## SOLO EVENTS BOARD

### SOLO EVENTS BOARD | December 27th

## CONTENTS

Figure 1: SMG Strut housing with Slotted Upper Hole.  
(Note: JRi housings have the slot on the bottom hole)

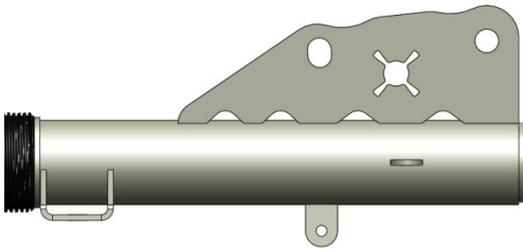
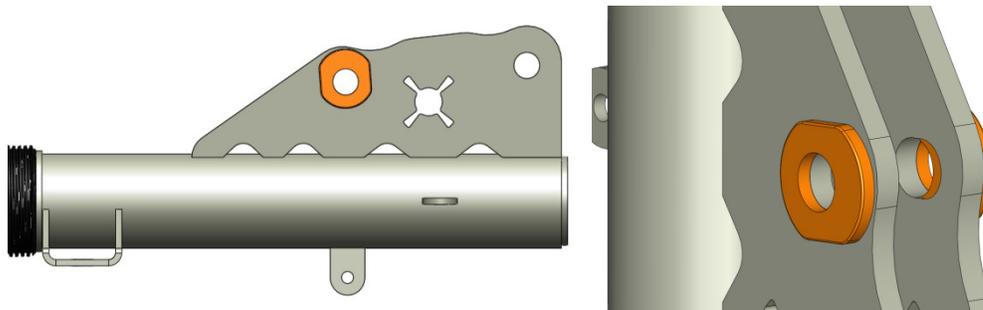
(4) Maximum negative front camber is 3.5 degrees. The approved technique to accomplish this is by using the Cortex P/N CFS-40-ALIGN-SMG, SMG Alignment kit (which includes camber slugs P/N CFS-40-1010), in all SMG strut housings. Installation guidelines are provided by Cortex Engineering. The JRi front strut housing will already have this feature. This CFS-40 kit is allowed, not required. But this IS the only allowed means to go beyond 3.0 degrees of negative camber. Potential tire clearance issues, resulting from this modification, are addressed in Section o). No machining of body to allow further travel. Caster: min. +6.35; max. +7.85. Camber plate PN MM5CC-5 or CCP197-05-09.

Illustration of strut housing modification discussed in section g) 4.

Figure 2: SMG Strut Housing with Camber Slug Installed.  
**REAR:**
